Subject: Waterford 3 SES  
Docket No. 50-382  
MASONRY BLOCK WALLS

SUBJECT: LOUISIANA POWER & LIGHT COMPANY  
WATERFORD STEAM ELECTRIC STATION  
1984 - 1165 MW INSTALLATION - UNIT NO. 3  
FOLLOWUP ACTION PLAN FOR CLOSURE OF MASONRY  
BLOCK WALLS CAT ITEM 6.2/6.3

Attached is the list of confirmatory items emanating from the NRR audit of the Masonry Block Wall design and installation. Four (4) of the sixteen (16) items have been resolved. Closure of the remaining items will be accomplished as follows:

ATTACHMENT 2-2

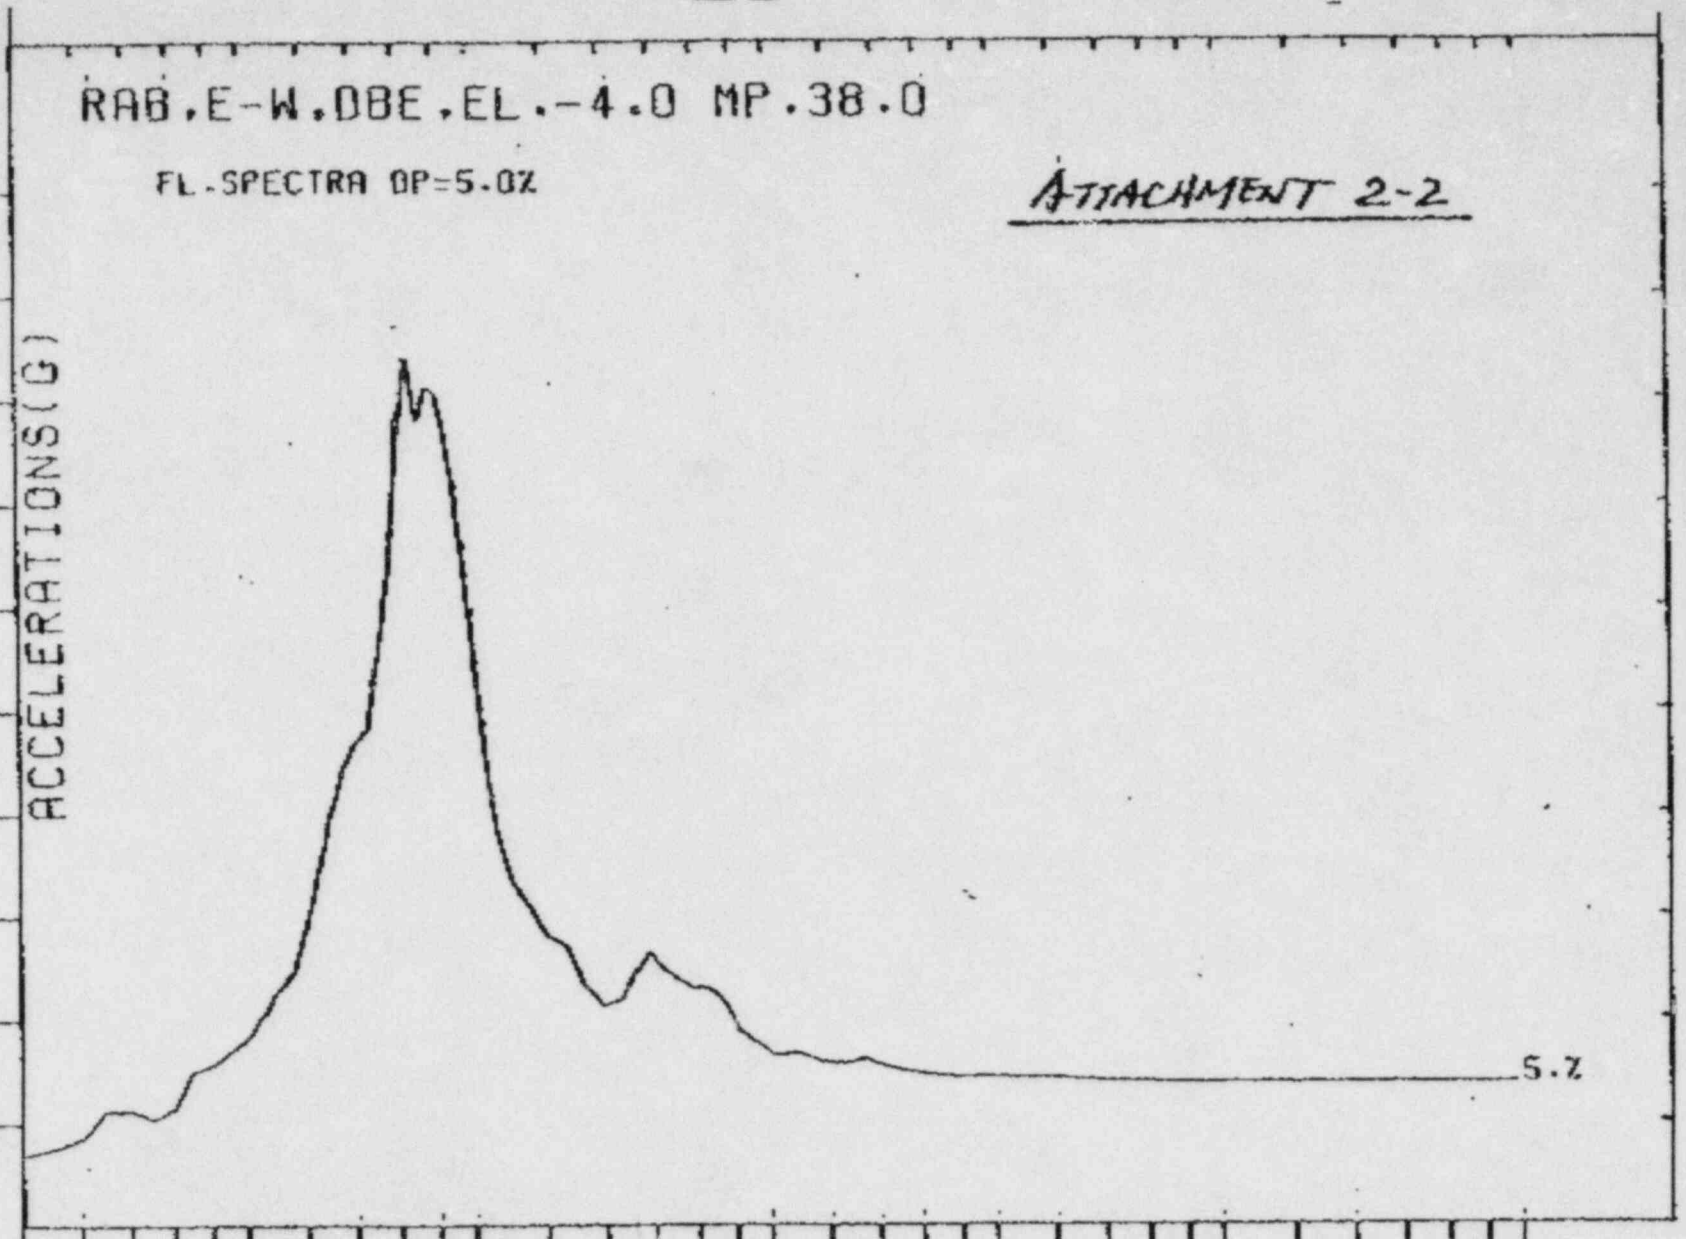
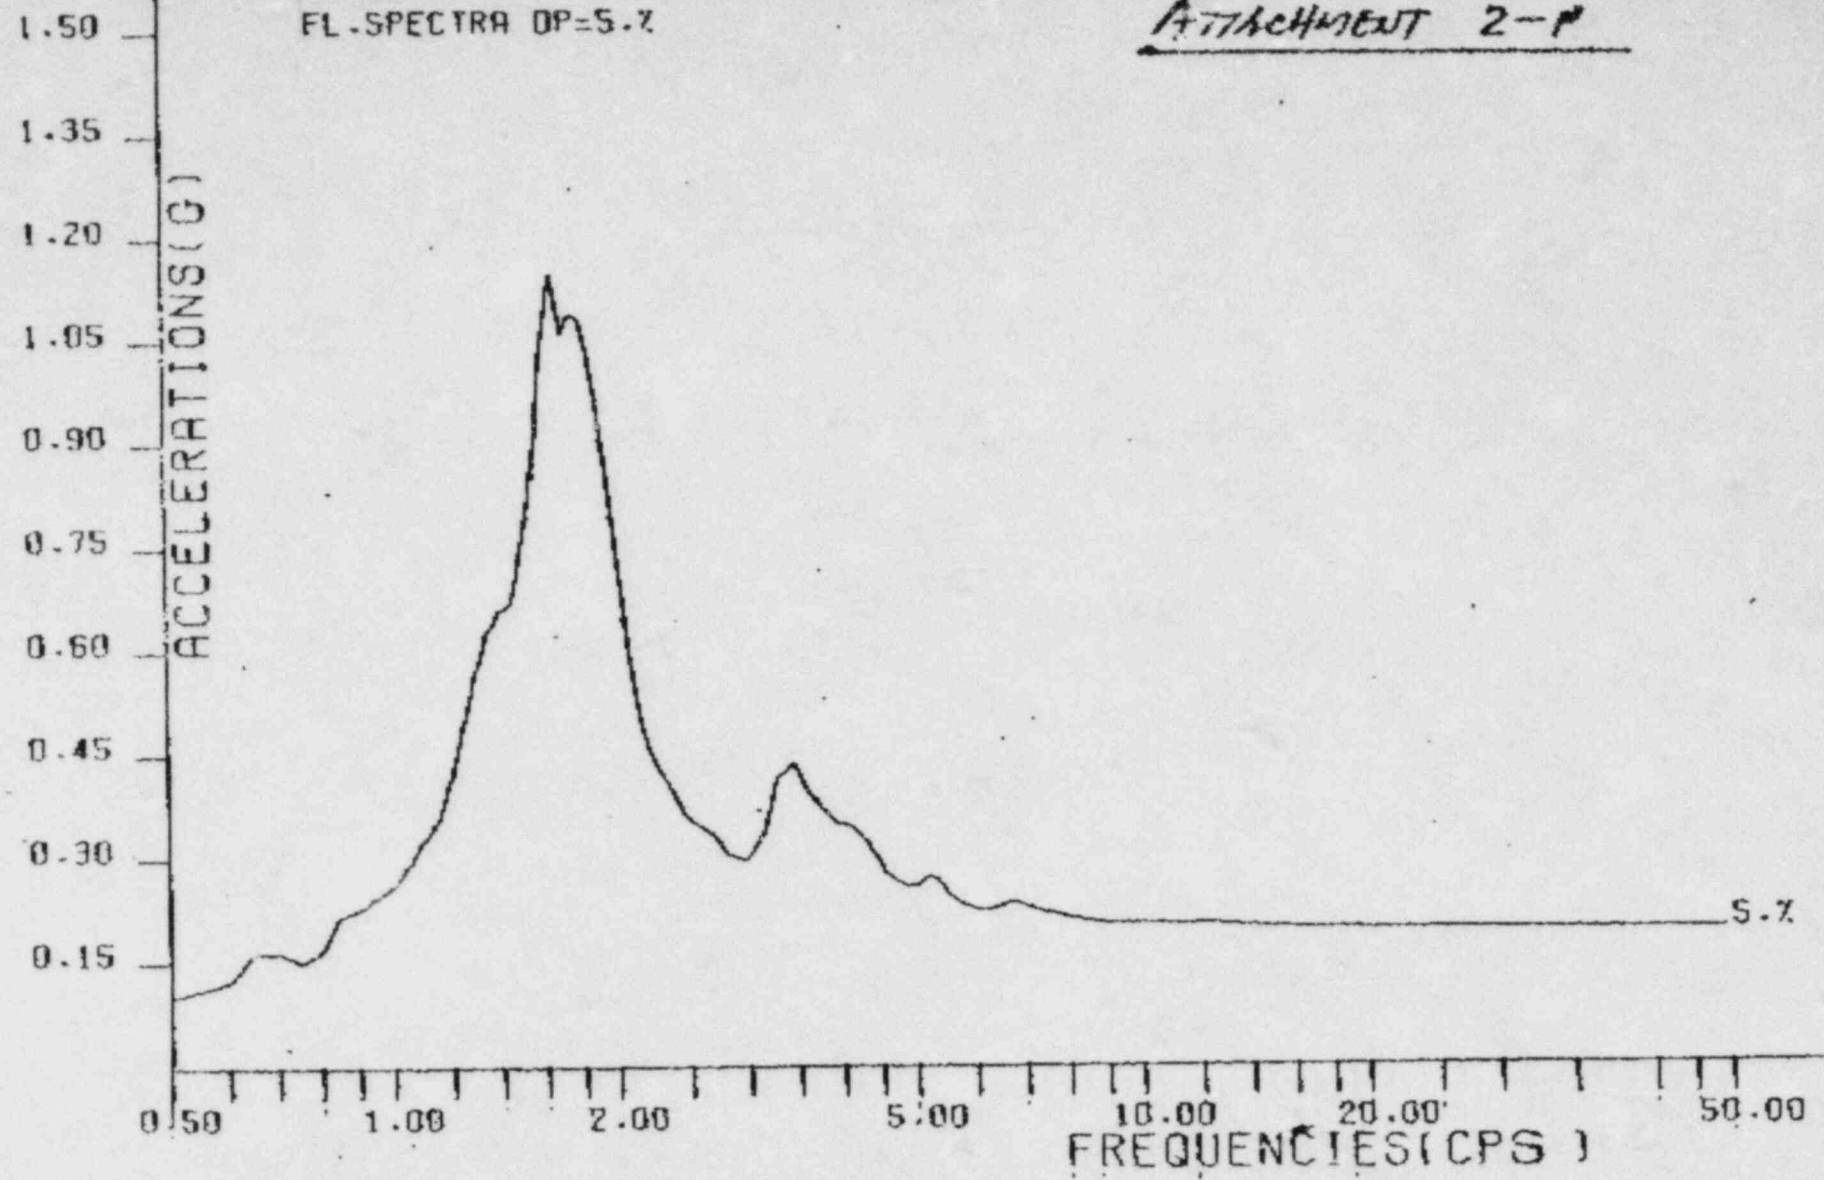
3.	Open	Clarify how the seismic acceleration value of .3g was selected for use in calculations. Confirm weight calculation. Confirm height limits used in analysis with as-built conditions.  Provide frequency analysis for both solid block and or hollow block walls. Provide frequency analysis for Wall S1 and S21.	A final report will be submitted by 10/8/84. Refer to the attached Memo No. ES-10131-84 for status.

As a result of NRC-SEB audit on the subject masonry block walls, we have committed to perform a seismic analysis to justify the use of the 0.3g acceleration using beam model. This memorandum, in response to the two references, is to provide the required analysis and to indicate that the 0.3g is adequate to be used in the masonry block wall design.

Attachments 2-1 and 2-2 are the floor response spectra curves established for 5% damping at Elevation (-35') and (-4') respectively. Computer printouts are also attached for ready pick-up of the "g" values.

- (5) The seismic required design "g" values were obtained from the 5% damping DBE response spectra curves, which were generated at EL-35'.00 and EL-4'.0. The use of 5% damping DBE response spectra curves is in accordance with the requirement specified in Waterford FSAR Table 3.7-1.

ITEM #5

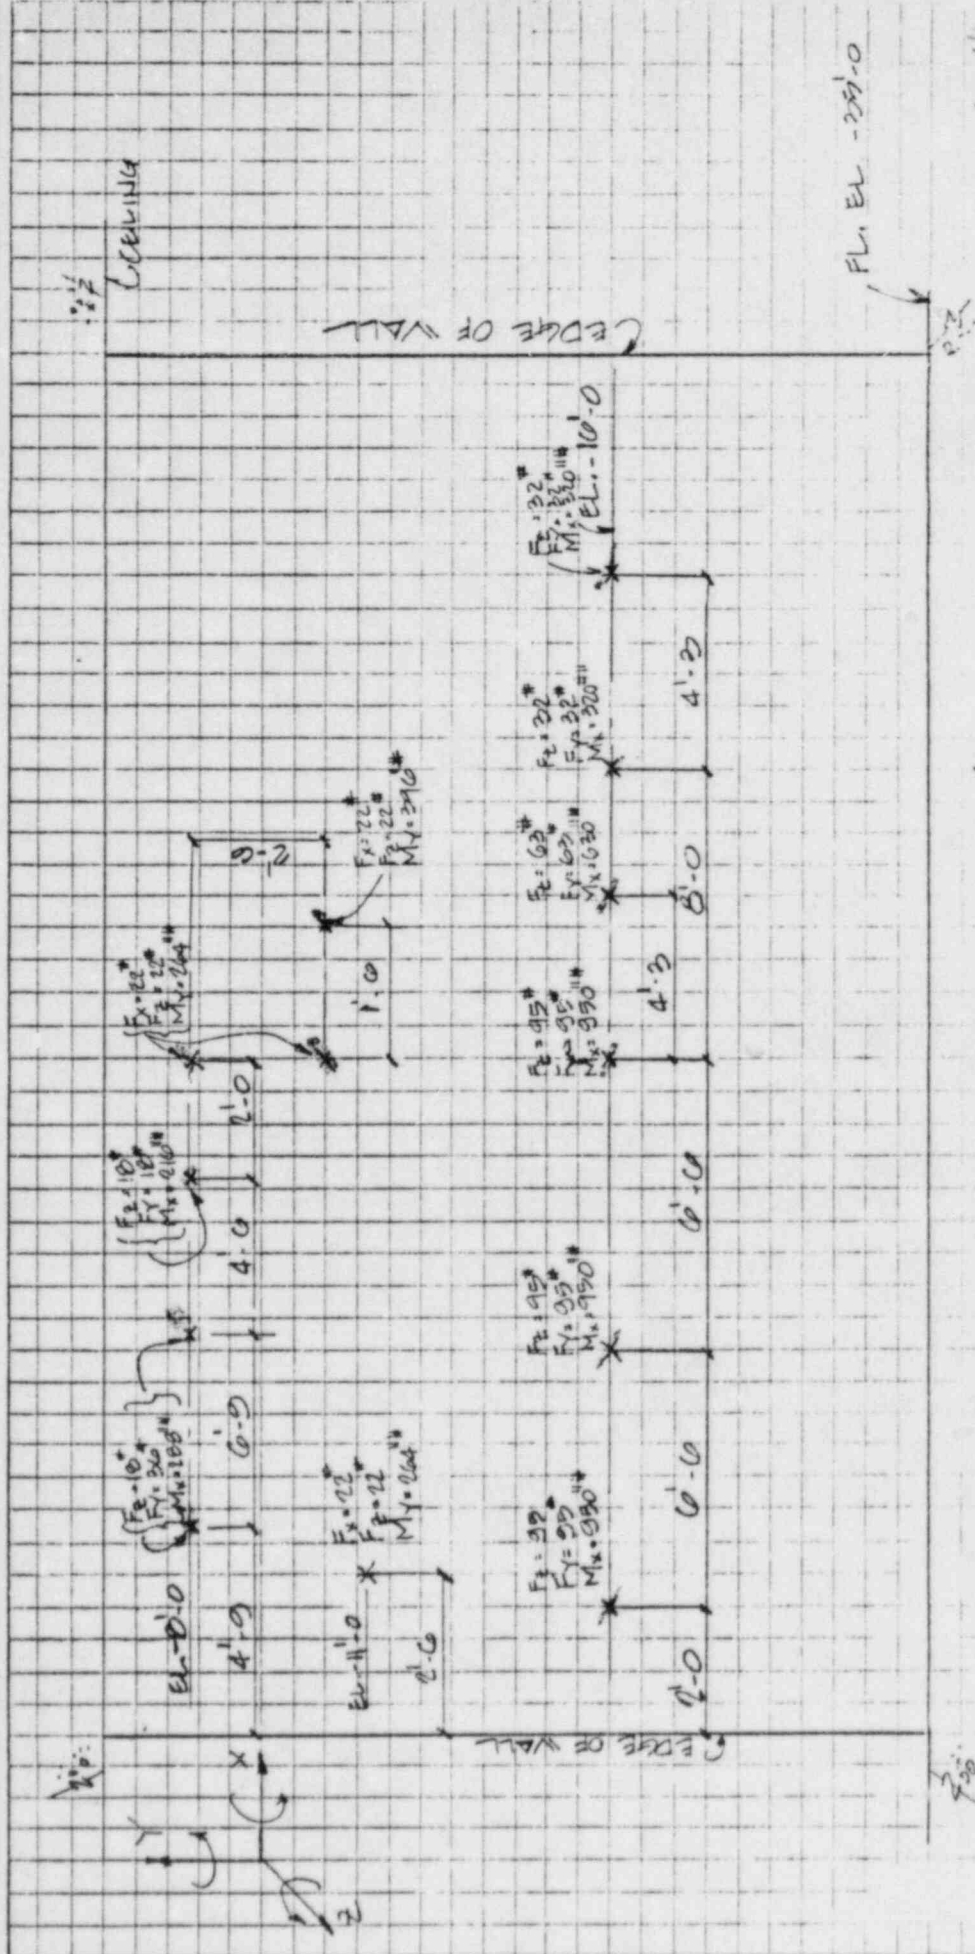
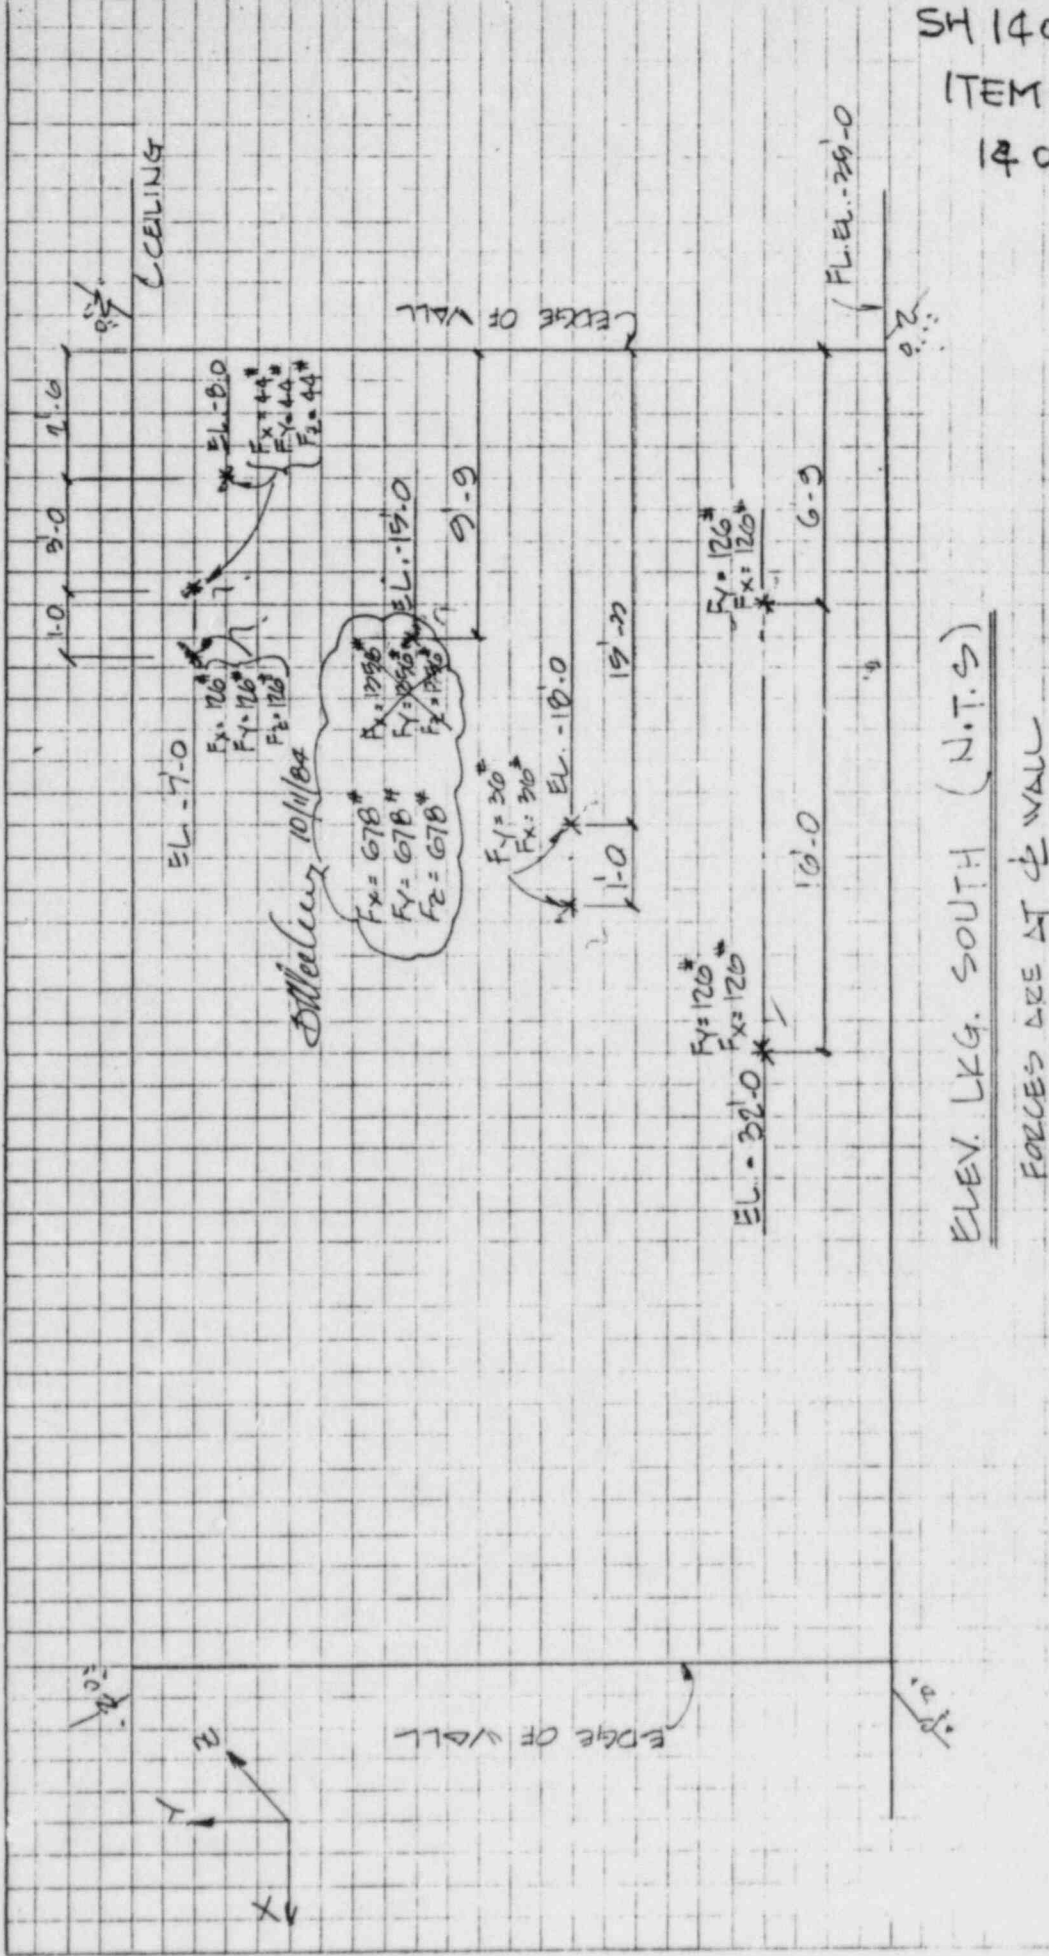
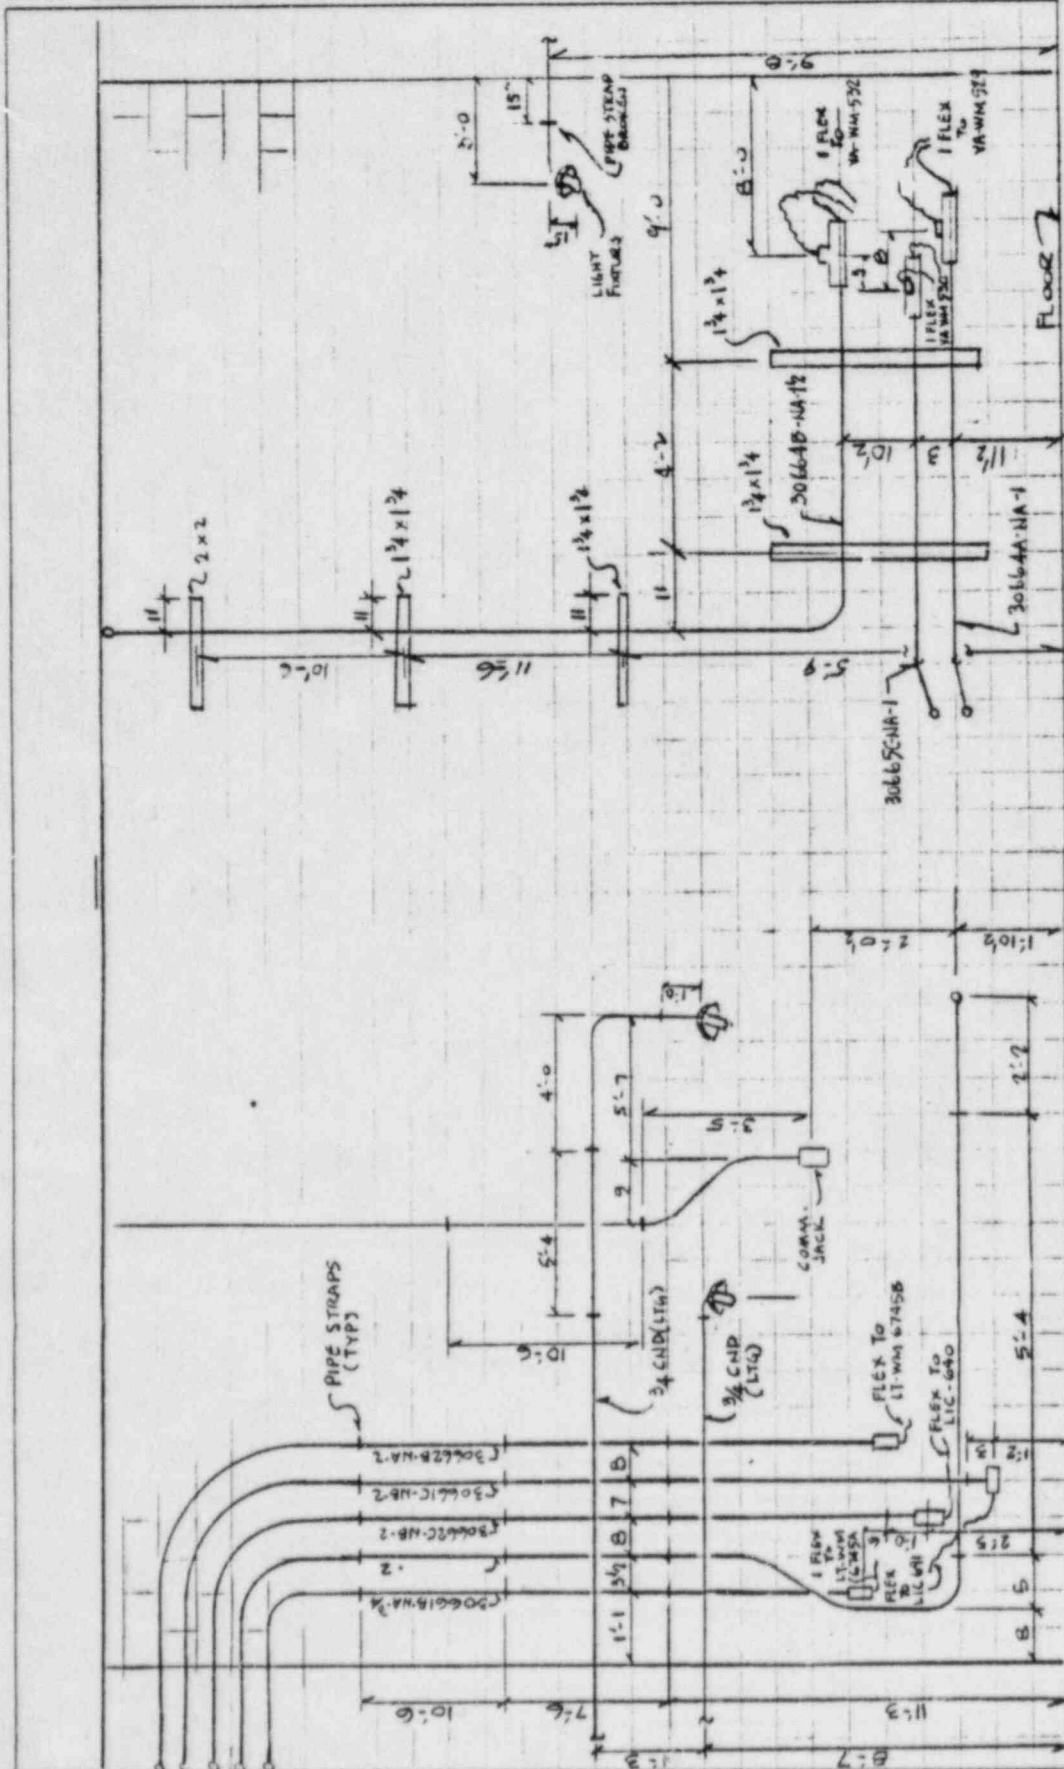
ITEM NO.	NRC REVIEW STATUS	QUESTION	RESPONSE
5.	Open	Verify the structural adequacy of Masonry Walls when miscellaneous non-seismic loads are considered. Select Walls S1, H2, H13, and W29 for this analysis.	Calculation Package No. 5 provides verification of wall S1. Verification of walls H2, H13 & W29 will be provided by 10/8/84.

6. - BASED ON THESE CALCULATIONS, WALL S1 IS STRUCTURALLY ADEQUATE AS BUILT.
